**Re: Supplement IV in Response to Data Requests and Workshop Queries in Support of the Application for Certification for the Sun Valley Energy Project (05-AFC-03)**

**Supplement IV in Response to  
Data Requests and Workshop Queries**

**Sun Valley Energy Project**

(05-AFC-03)

Sun Valley SACTI Modeling  
 % hours/ Annual (All Seasons)  
 Visible Plume Length  
 FULL LOAD  
 Good Visibility Hours  
 Red = 20% or more HRS

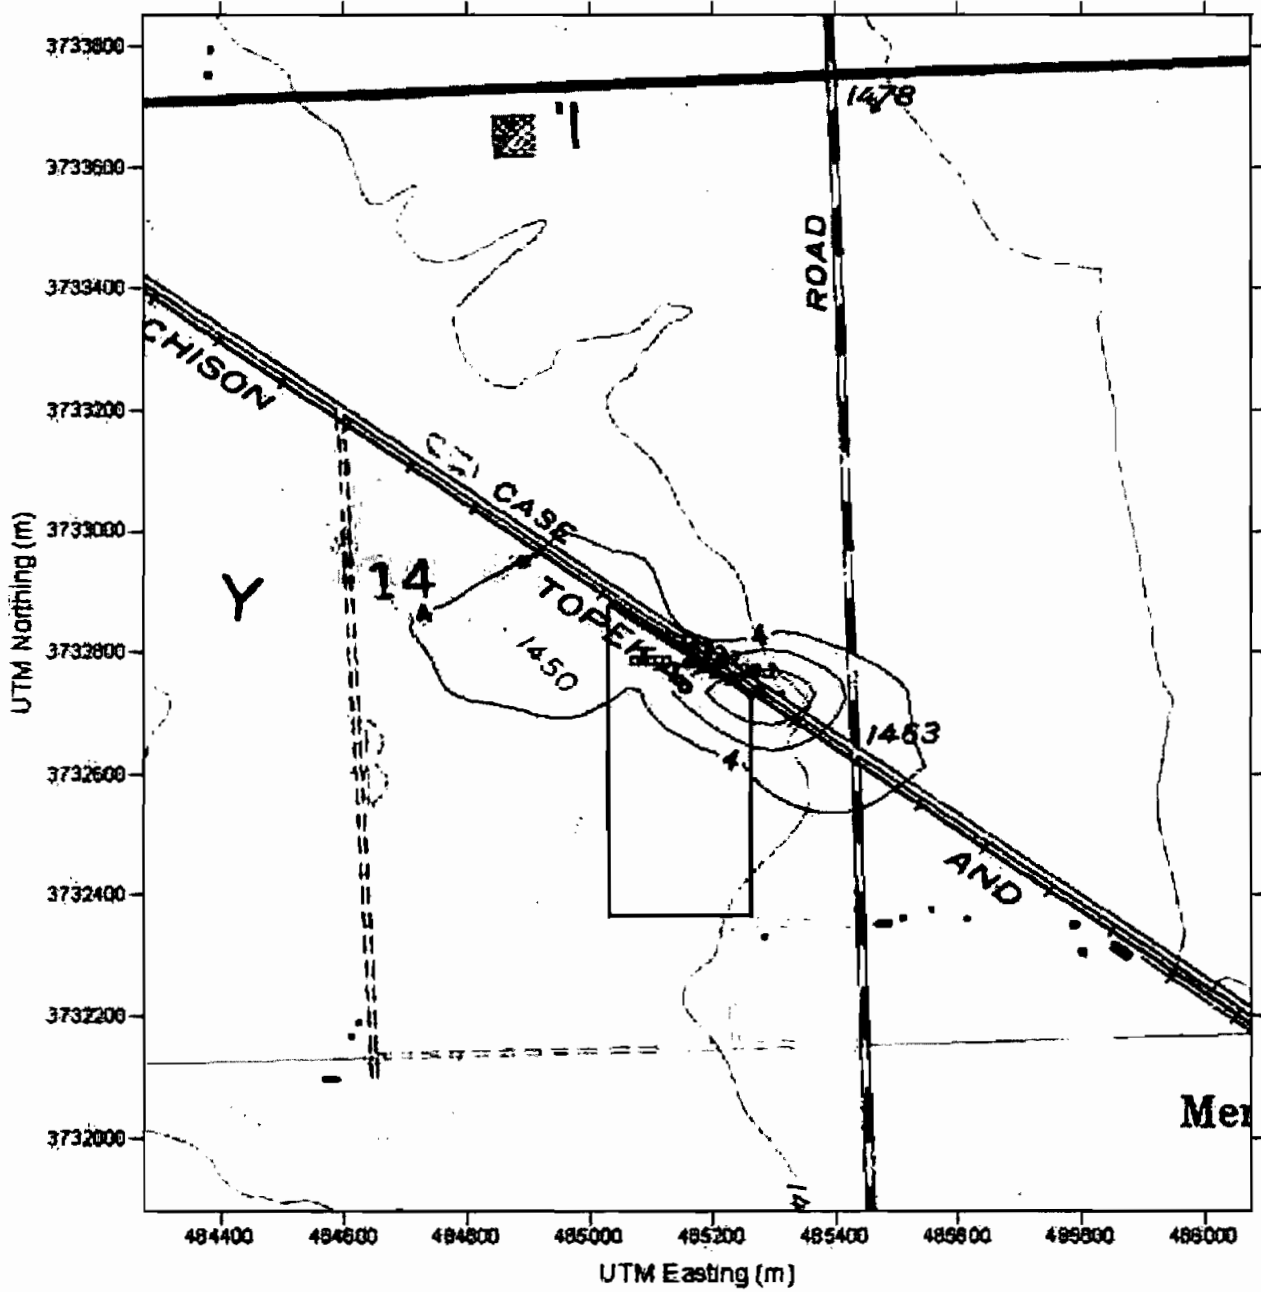
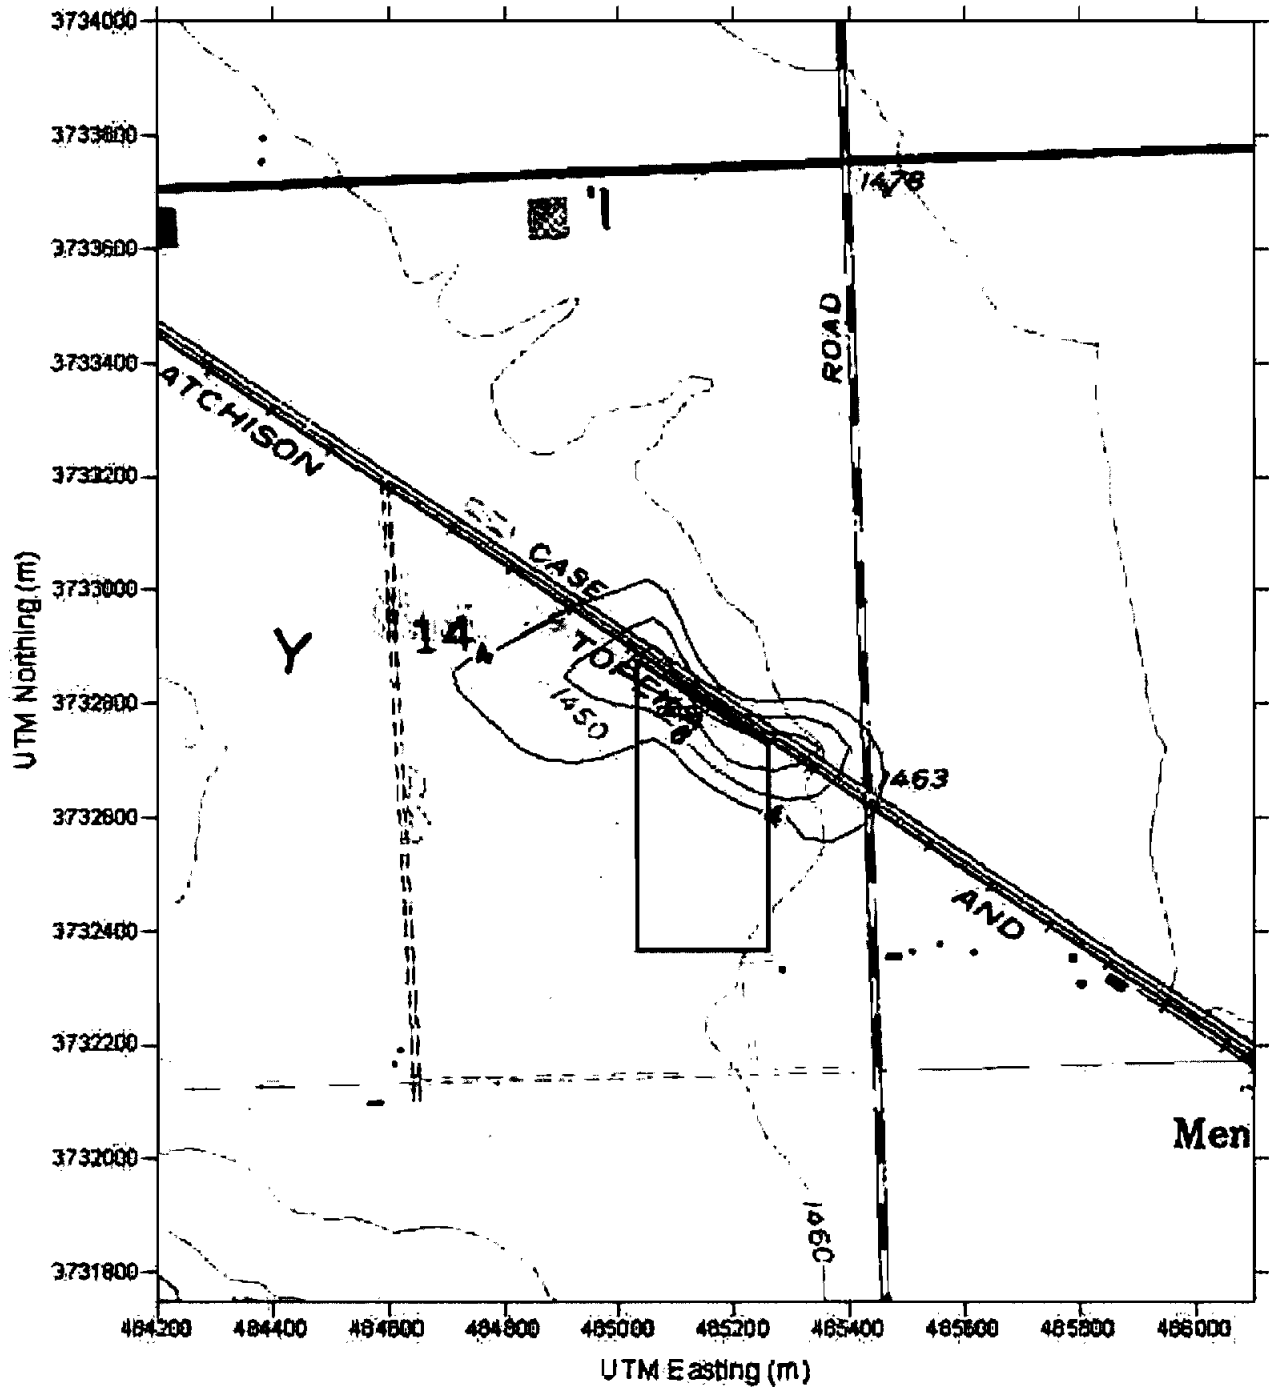
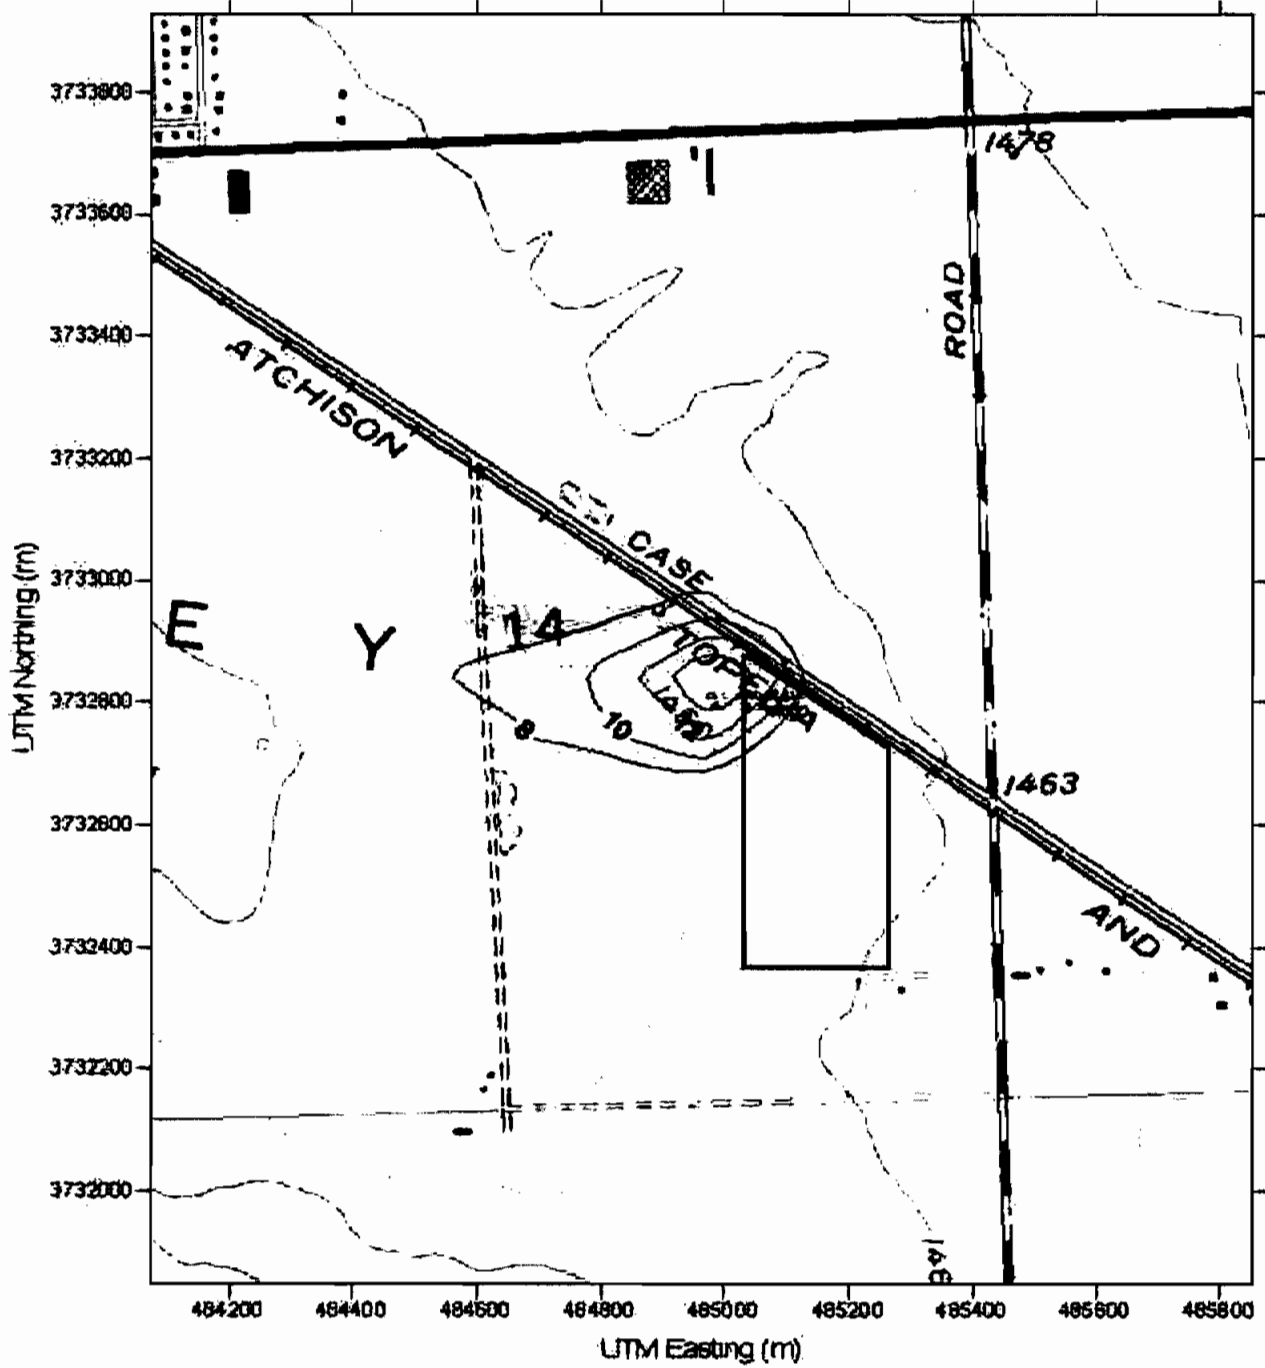
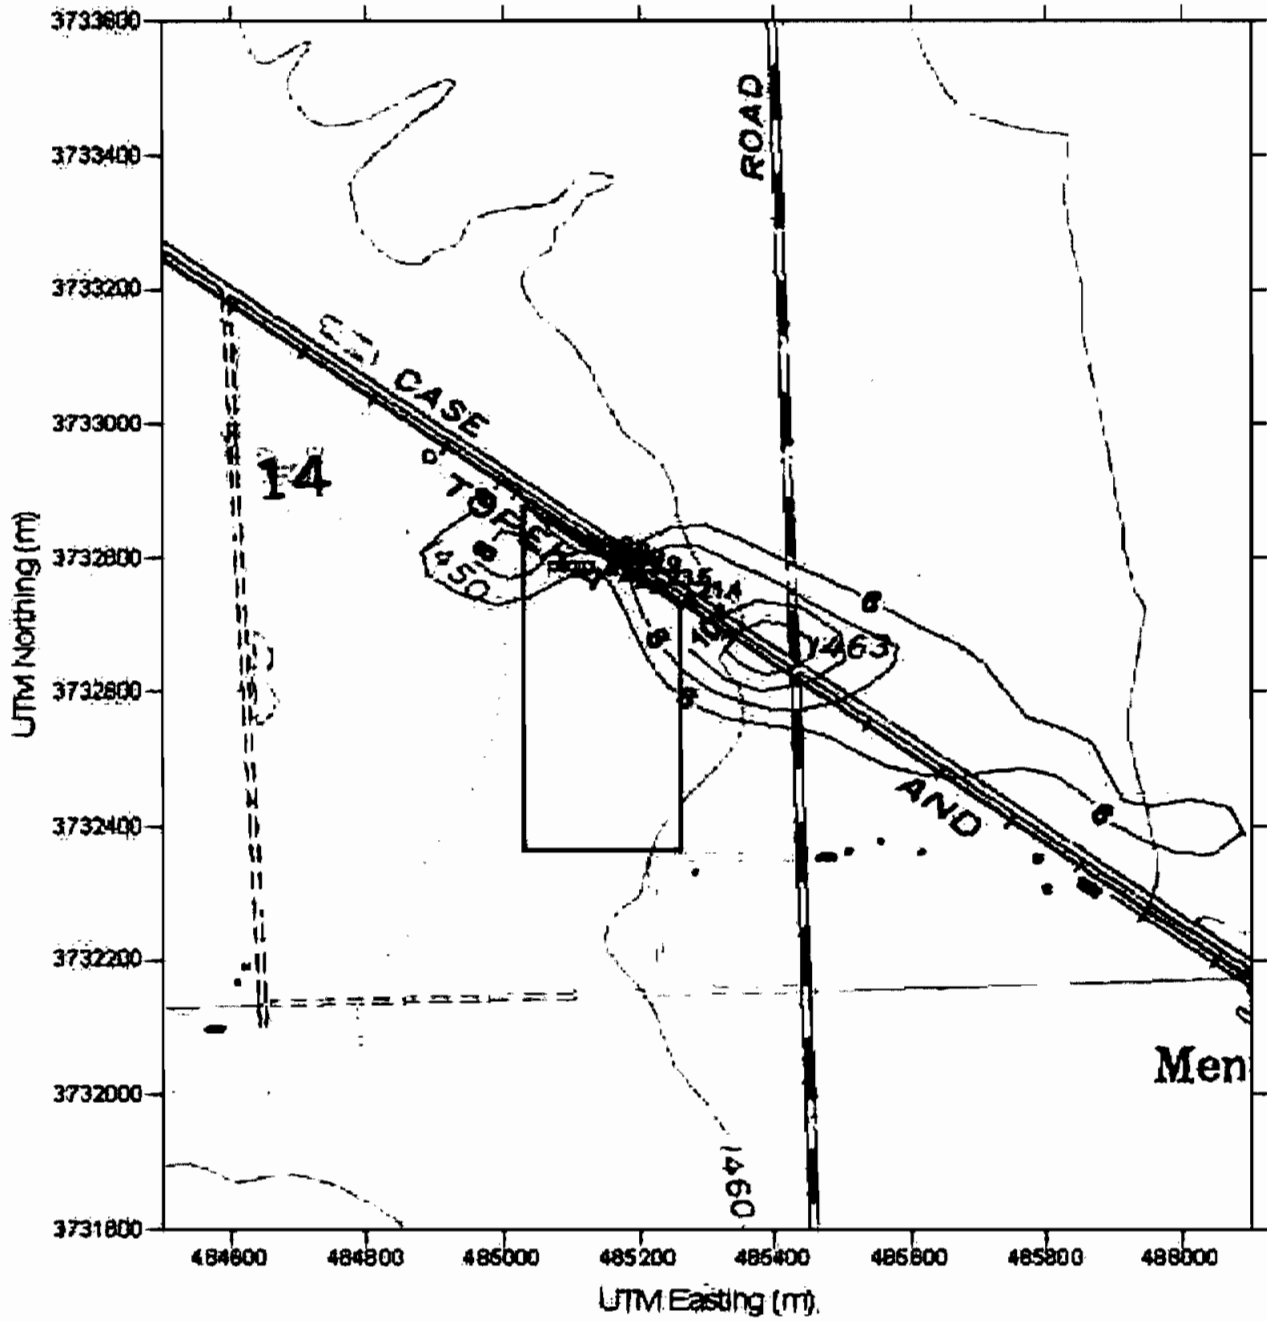
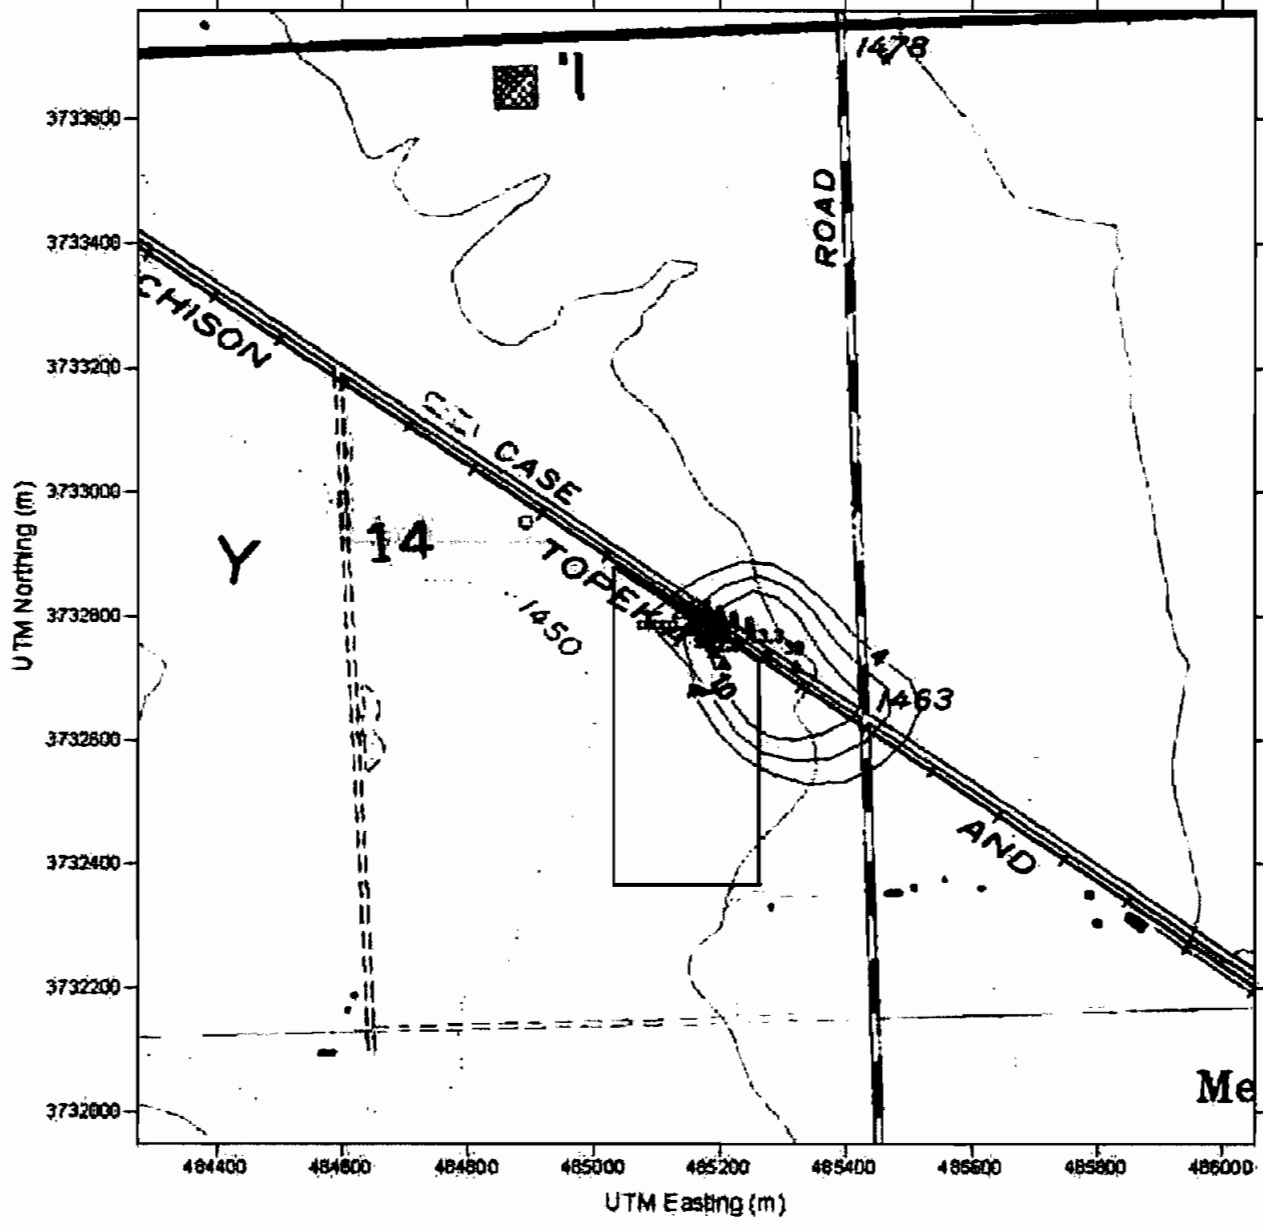
DR67. *If the applicant performed a visible plume modeling analysis in support of the AFC Visual Resources conclusion, please provide the modeling results, any meteorological data used in the analysis, a full discussion of all assumptions, the name and version of the model used, and all model input and output files. If a modeling analysis was not performed, please provide any analysis that supports the visible water vapor plume discussion in the AFC.*

The results of the cooling tower analysis are summarized in Attachments 1-5 for the tower for the annual and seasonal seasons. The attachments present the frequency distributions of the primary model output variables, namely plume length and height, which is depicted by downwind sector and radial distance from the center of the cooling tower array.

The SACTI results are summarized below for the annual and each of the four seasons. The annual summary indicate that the majority of visible plumes will be less than 250 meters (820 feet) in length. Modeling results indicate that, based on total hours, plume formation will occur 20 percent of the time during valid visible hours at locations up to 600 meters (1,968 feet) from the site. Larger downwind visible plume lengths are possible and are predicted during the spring and winter seasons, but the downwind visible plume length will be less than 400 meters (1300 feet) for 70 percent of all the hours where a visible plume will form. SACTI also predicts that the visible plume height will average 150 meters, and have a median radius of 40 meters (131 feet) on an annual basis. For the winter season, the average plume length (when visible) will be longer, at 325 meters (1066 feet). For winter, SACTI predicts an average visible plume height of 180 meters with a median radius of 45 meters, similar to the annual averages.
